# DESIGN REVIEW BOARD

DRB2016-23

Design Review for renovation of existing building façade, new landscaping and associated site work.

## HOLIDAY VILLAGE SHOPPING CENTER - EXISTING SEARS REMODEL - PETSMART

SHEET:  
A1.0

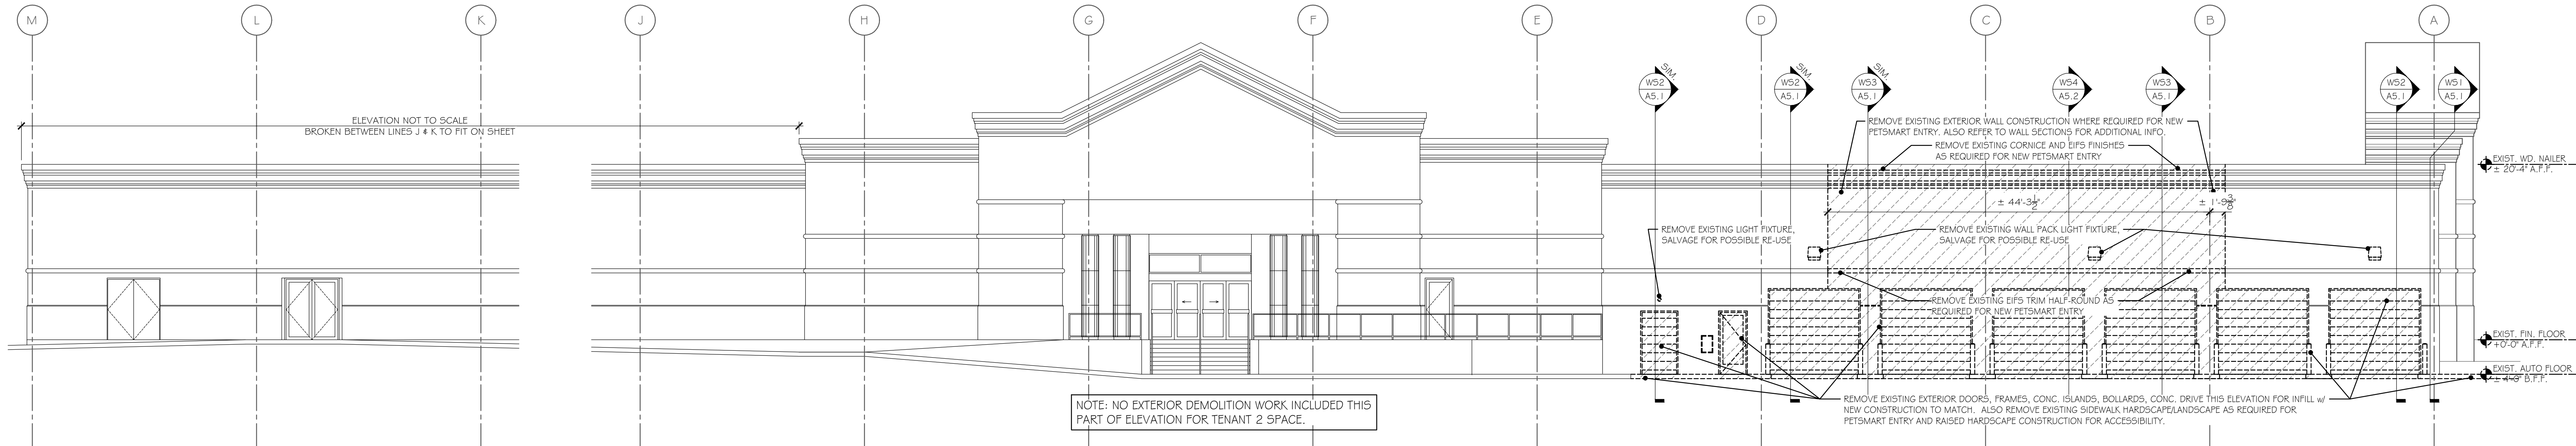
The current parking lot layout will remain the same; however, it will be updated to include landscaped islands at both ends of each row of parking, and additional ADA accessible parking spaces. The applicant is proposing ramps that end both on the north side of the building and that end on the west side of the building. There is a curb cut shown on the north side, but not the west side. A curb cut will need to be added on the west side, and

crosswalks leading to a row of parking that has ADA accessible parking spaces and loading zones shall be added for both sides. The existing parking lots immediately to the north and west of the building provide a total of 246 parking spaces. For the proposed uses of the three new spaces, 212 spaces are required, so the loss of a few parking spaces to provide the loading area for the ADA accessible spaces is not an issue. Additionally, where the new loading bay is established, a crosswalk needs to be provided across that drive aisle because there are access/service doors at that corner of the main shopping center building. Staff also recommended that the applicant provide bicycle parking as there are residential neighborhoods immediately to the west and southwest of the site, and the applicant agreed to add this feature.

The subject property is nonconforming with regards to OCCGF Chapter 44 – Landscaping, it is required that it come into compliance to the maximum extent possible. As aforementioned, the applicant is updating the parking lot to include landscaped islands on both ends of each row of parking. The floor plan/site plan submitted also shows landscaping along the north of the building, in front of and behind the new ramps. Staff recommends that the landscaping at the PetSmart entrance be symmetrical, which would mean adding a landscaped bed behind the east ramp.

These landscaped beds should be designed to drain under the ramps, which can be done during construction with appropriate engineered plans. The plant species in these bed should also be appropriate for how much shade those beds will have. The accessible ramp that curves around the building to the east side is shown where there is a well established landscaping bed with trees and shrubs (see attached site photos in Exhibit D). Those trees and shrubs should be relocated to the parking lot landscaped islands. There should also be a landscaped bed abutting that ramp along the sidewalk, as well as immediately south across the sidewalk should be landscaping. Staff believes this is indicated by the key for Sheet A1.0 is consistent with these later improvements, but it is not labeled. A landscaped plan for these beds also needs to be submitted and reviewed by Staff.

- ◆ The applicant shall revise the photometric plan to show the updated building mounted lighting fixtures and revise the luminaire schedule and statistics. This includes providing fixture cut sheets to Staff to review for compliance with OCCGF Chapter 40 - Outdoor Lighting.
- ◆ The applicant shall revise the site plan to show a curb cut on the west side of the building at the base of the accessible ramp.
- ◆ The applicant shall revise the site plan to show cross walks at the curb cuts, as well as show the ADA accessible parking for both of those areas.
- ◆ The applicant shall provide crosswalk across the loading bay drive aisle to the shopping center.
- ◆ The applicant shall revise the site plan to show the stop sign and painted stop bar.
